Our ref: RL-01-1741-02

**Multi Dwelling Housing Development Application, Yamba**

**Independent Peer Review – Flood Emergency Management Plan**

Figure 3 Clarence Valley Council flood mapping for 1 in 100-year flood (left) and the 'Extreme Flood' (right) (Note: Mapping is not inclusive of the effects of climate change)

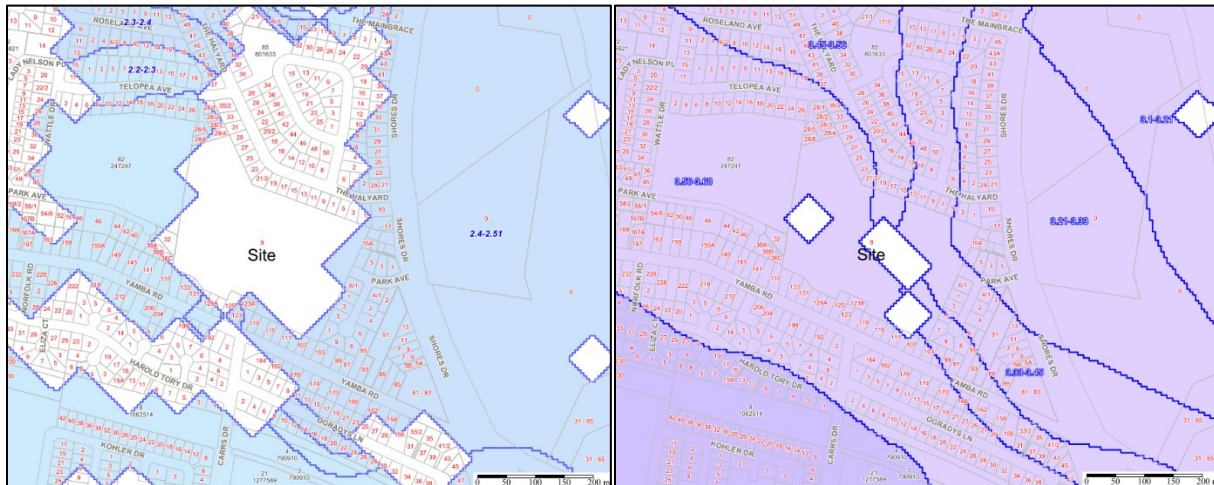
The site has previously been filled to a level of approximately 2.8m AHD such that the majority of the site is located above the existing climate 1% Annual Exceedance Probability (AEP) flood level of 2.51m AHD (i.e., above the 1 in 100 AEP flood level, but with no allowance for climate change). As such, the site is mostly mapped as outside of this level however Council's mapping indicates that it is within the Extreme Flood extent (noting this also does not have an allowance for climate change) (**Figure 3**).

**Figure 7 Proposed community clubhouse plan (Source JKH, 2022)**

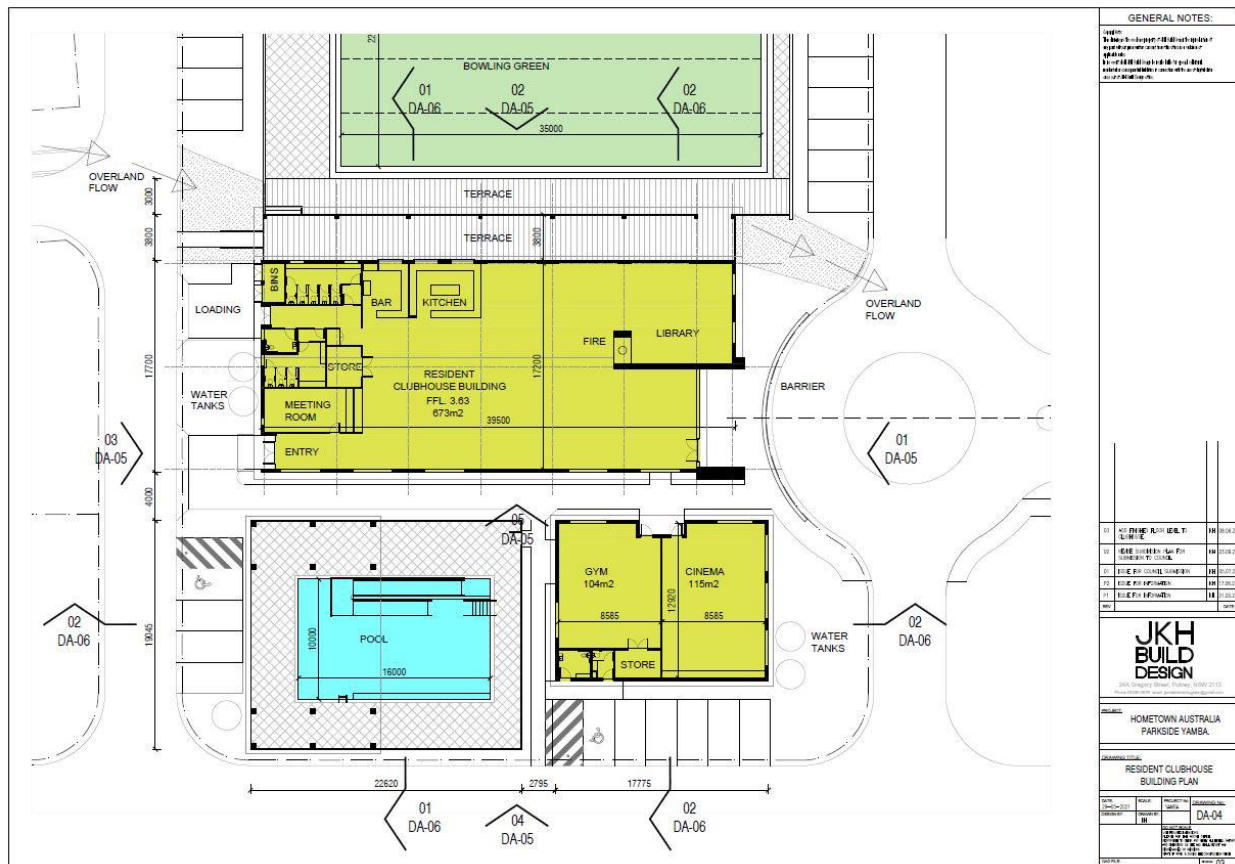
Despite being proposed to be built above the reported extreme flood levels, the suitability of the proposed community clubhouse as an evacuation shelter is another matter in and of itself. The FEMP puts forward that the clubhouse serve as an evacuation shelter for “most” of the development’s residents (i.e., those that have no need to evacuate early) as well as some members of the local community. A plan view of the clubhouse is provided in Attachment C to the FEMP and is reproduced in **Figure 7**.

As can be seen, the clubhouse’s footprint is 673 m<sup>2</sup>. In the event of a major flood, the entire township of Yamba would be cut off, and residents would need to be able to survive without outside assistance for at least 2-3 days (Yamba Floodplain Risk Management Study, WMA, 2008). However, in the floods of

February and March 2022, access to Yamba was cut off for almost an entire week<sup>4</sup>. Although a specific capacity is not provided, the FEMP proposes to accommodate a significant number of people plus their pets (say 272 people, the proposed population of the development) in building whose footprint is 673 metres squared, for up to seven days. This would equate to a maximum space per person of 2.5 square metres, if none of the persons identified for medical evacuation departed the site. This is considered to be an insufficient space for the potential duration required for shelter during a flood event.

As can be seen in the floorplan in **Figure 7**, there are no showering facilities visible in the proposed community clubhouse. The FEMP states that the clubhouse would be stocked with adequate food, water, pet food, medications, power and other necessities to provide the residents' potential week long refuge. With the possibility of the flood refuge being in operation for up to a week temporary bedding and other relevant items would need to be provided at the shelter. There are insufficient bathroom facilities (only 8) on the floorplan of the clubhouse, including a single accessible stall. As stated in the Support for Emergency Management (DPE, 2022), consideration must be given to the availability of on-site sewage services, yet the FEMP provides no indication that this will be available at the site. The proposed gravity sewer is to connect to existing sewer infrastructure via the existing station to the west of the site. This station appears to be set at 2.3 mAHD and would be expected to become inoperable in a 1 in 100 AEP flood event and events rarer than this.

Additionally, the proposed floor level of the shelter area would need to be further elevated to 4.5 mAHD to allow for projected climate change, otherwise there is potential for the refuge itself to be inundated.
